New 2022+ Model Rotary Connector Changed to 5 cords, so it able to provide 24V output for rotary if needed

Drawed by Jack
2022 04 16
LabelMark 2022+ Model
Special design for
am.co.za

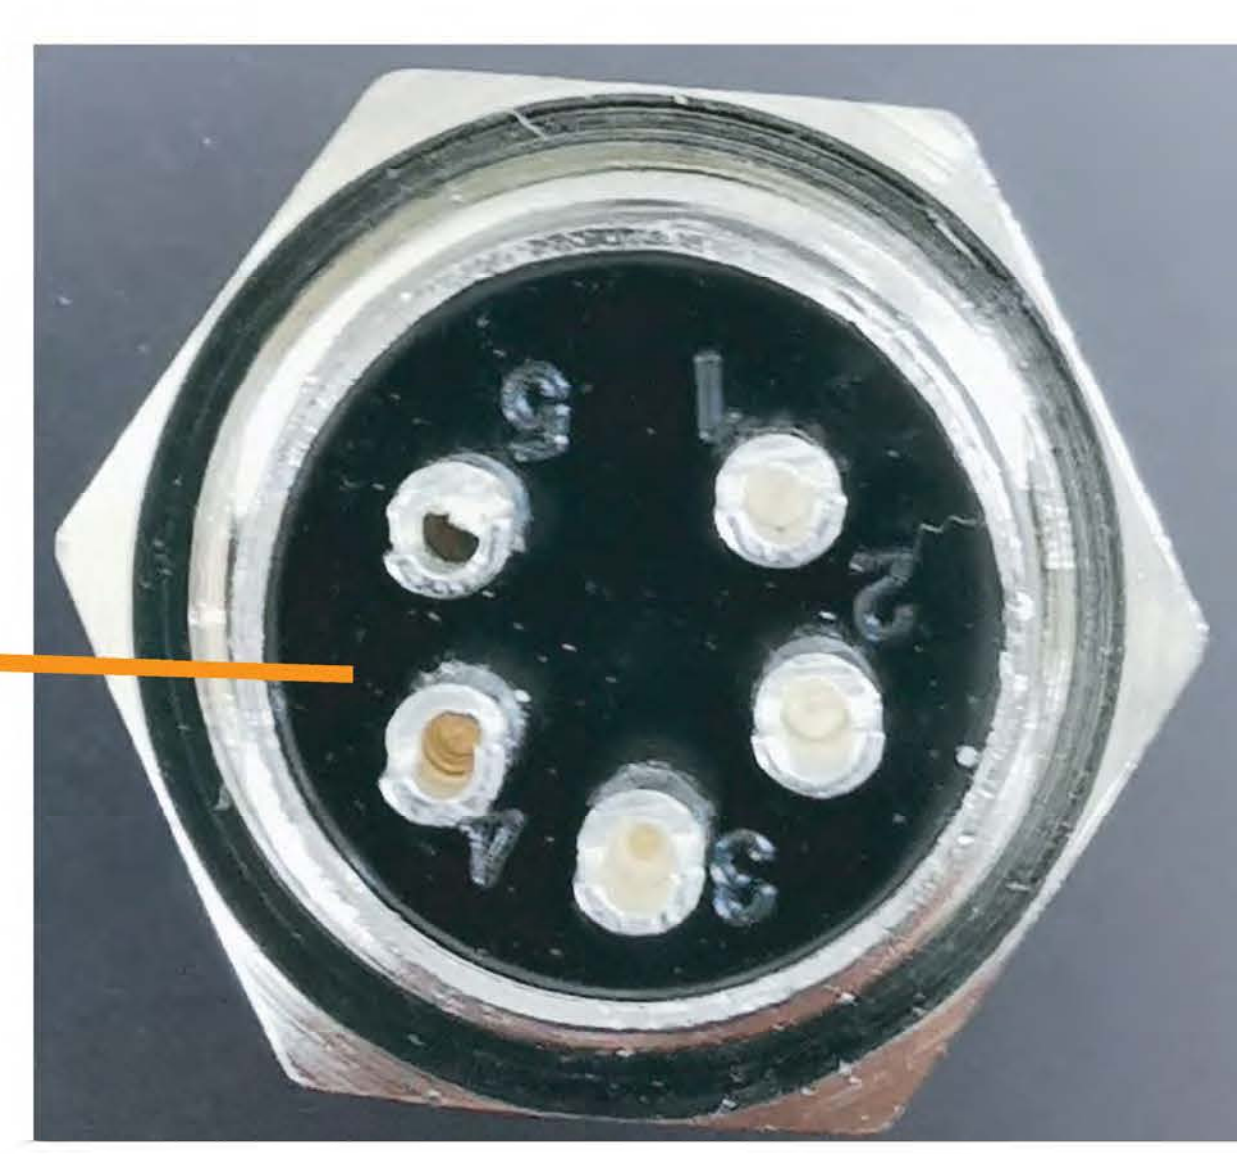
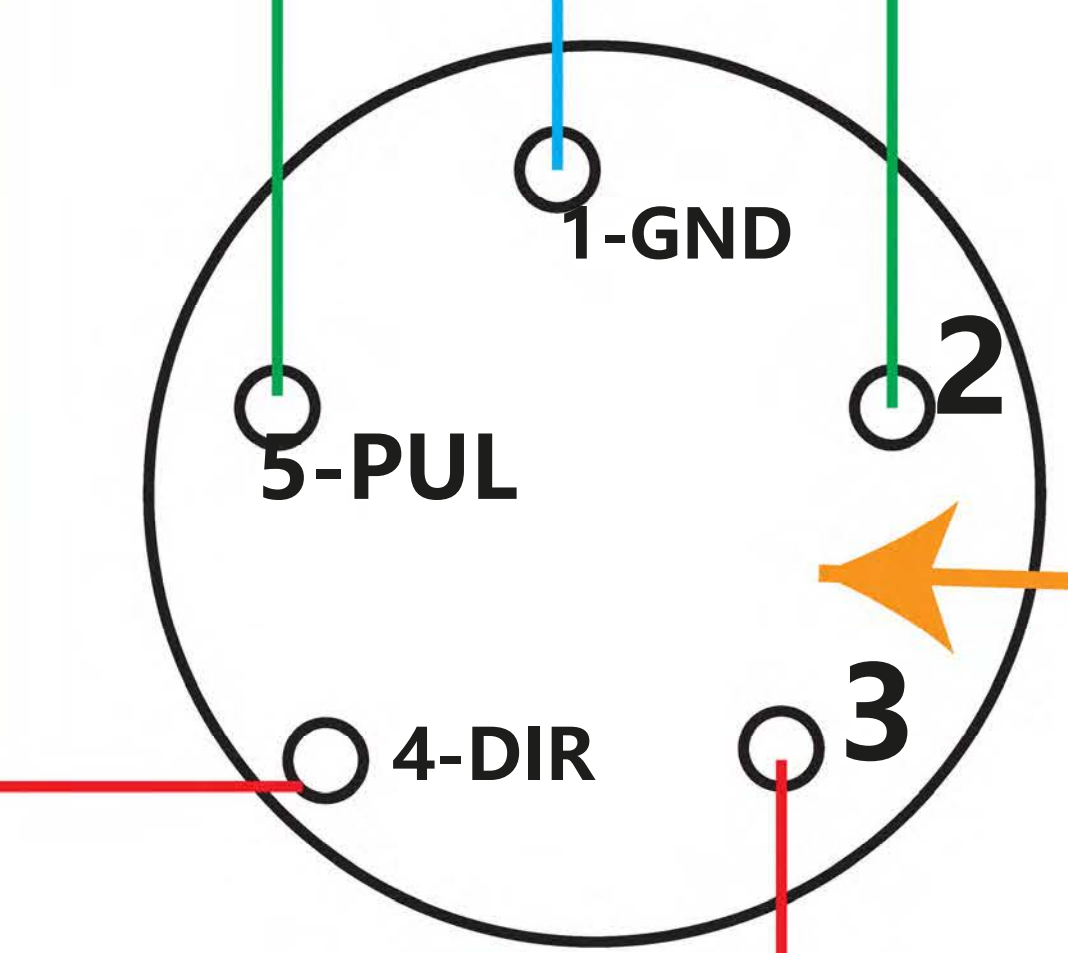
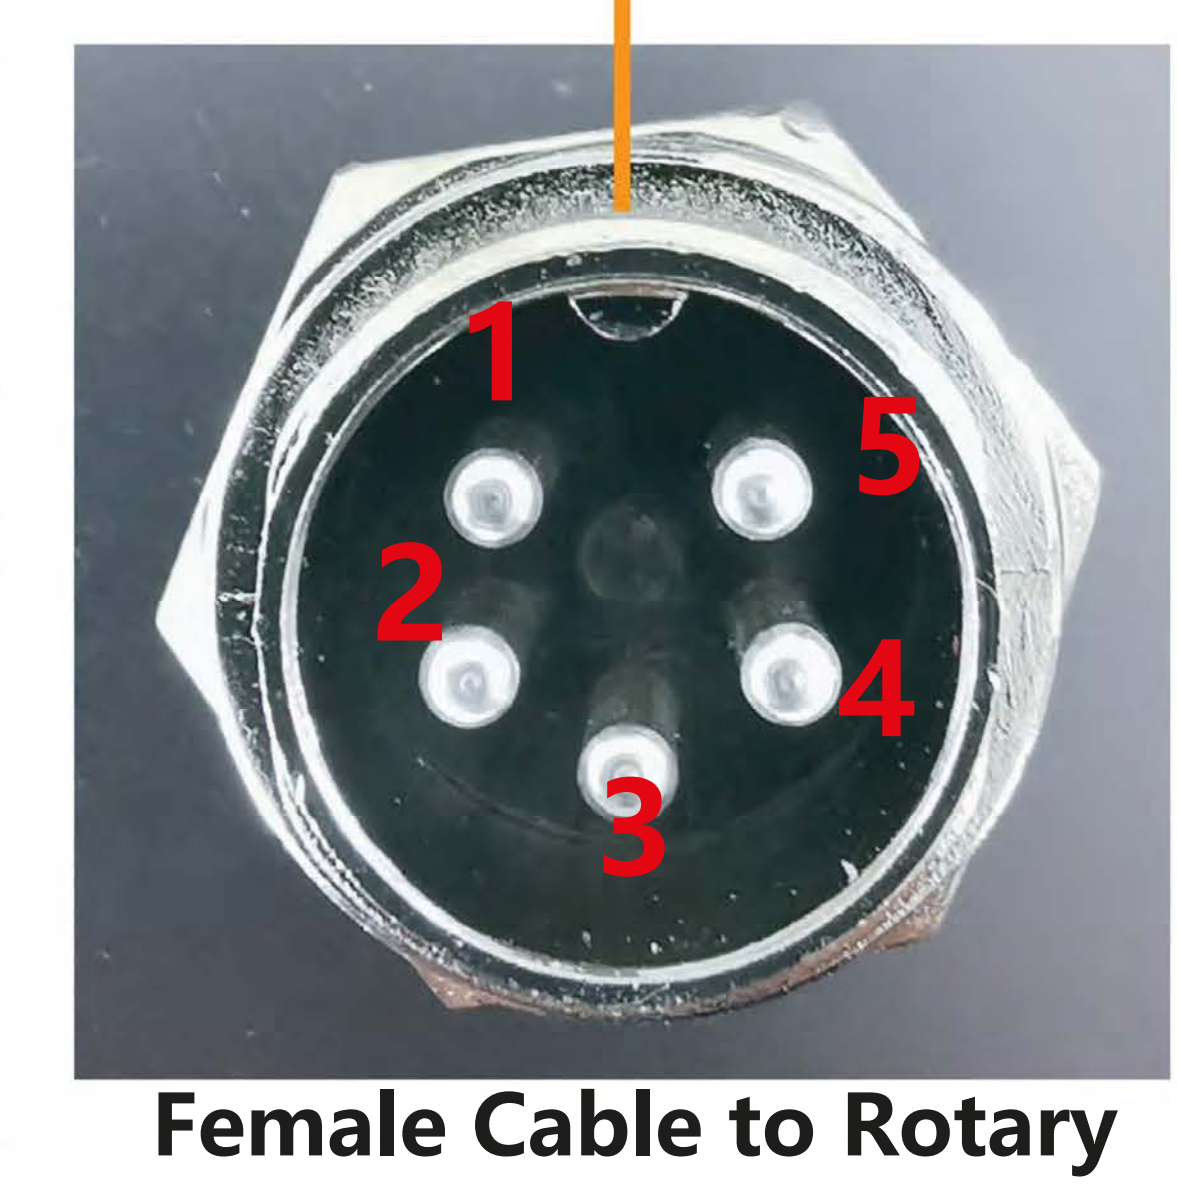
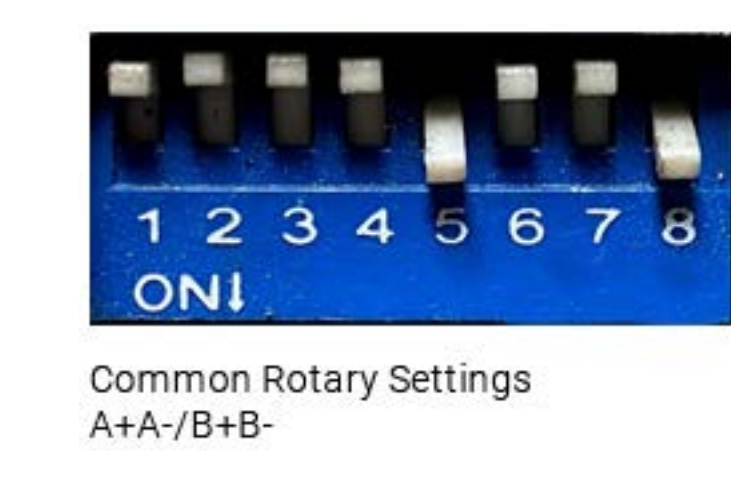
24V Output on
PIN 2 _ GND
PIN 3 _ +24V

Rotary Stepper Motor Driver Signal
PIN5 _ PUL+
PIN1 _ PUL-
PIN4 _ DIR+
PIN1 _ DIR-
